| M. REVIEW | DCMS STATUS = APRV AUGUST 18, 2006 13:52 | REFERENCES | NOTES | ENGINEERING CHANGE NOTICE ECP 050201791-5 REV. 0 IF SUPERSEDED, ARE THE ORIGINAL ECP ASSESSMENTS IMPACTED? <input type="checkbox"/> YES <input checked="" type="checkbox"/> NO PREPARED BY/DATE:(ORIGINATOR) APPROVAL REQUIRED FOR THE QUA. DCS OF 14001 FOR FIELD EOP'S VERIFY BY: INITIALS BAKER RAY 8/16/2006 VERIFIED BY/DATE:(CHECKER/INE) SARKIS VINCENT 8/17/2006 APPROVED BY/DATE:(PLS) | QC (NSR) UNIT 1 SAN ONOFRE NUCLEAR GENERATING STATION DECOMMISSIONING P & I DIAGRAM CIRCULATING WATER SYSTEM SH. 1 |

ENGINEERING CHANGE (ECN) A44561 5178330DE REV 0

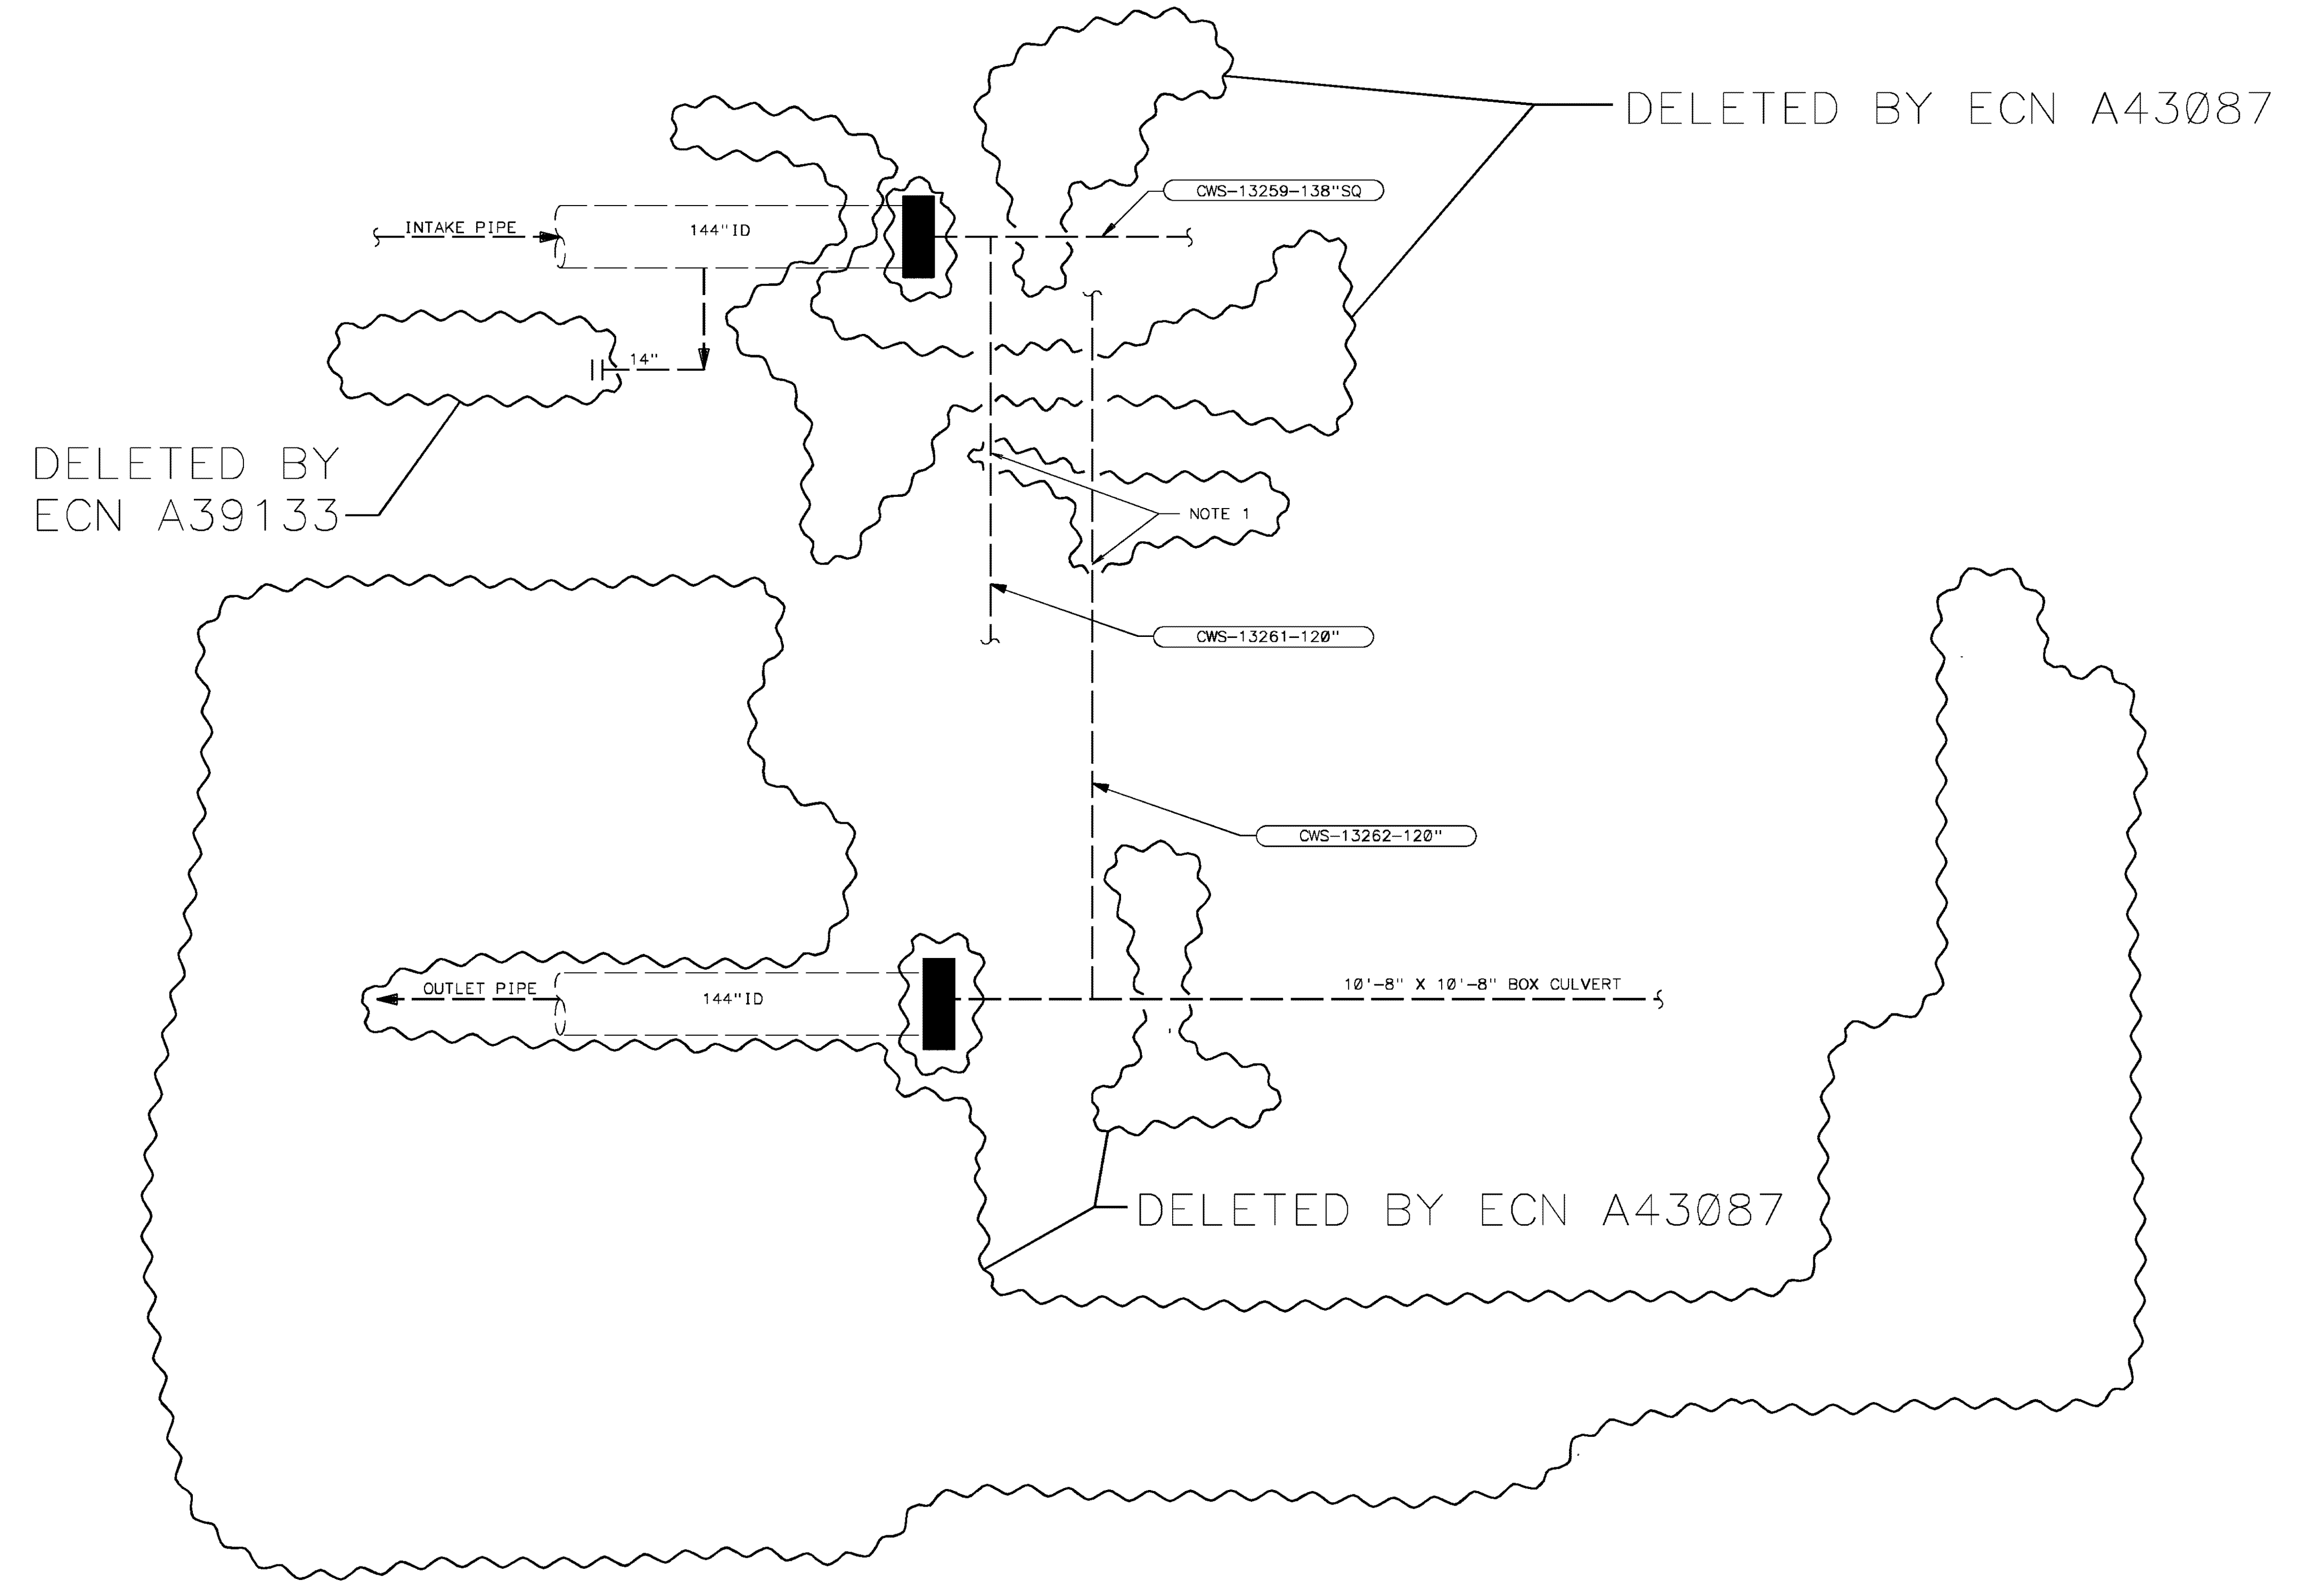
- NOTES:
1. INTAKE STRUCTURE DEWATERED FOR FUTURE SLURRY.
 - 2.
 - 3.
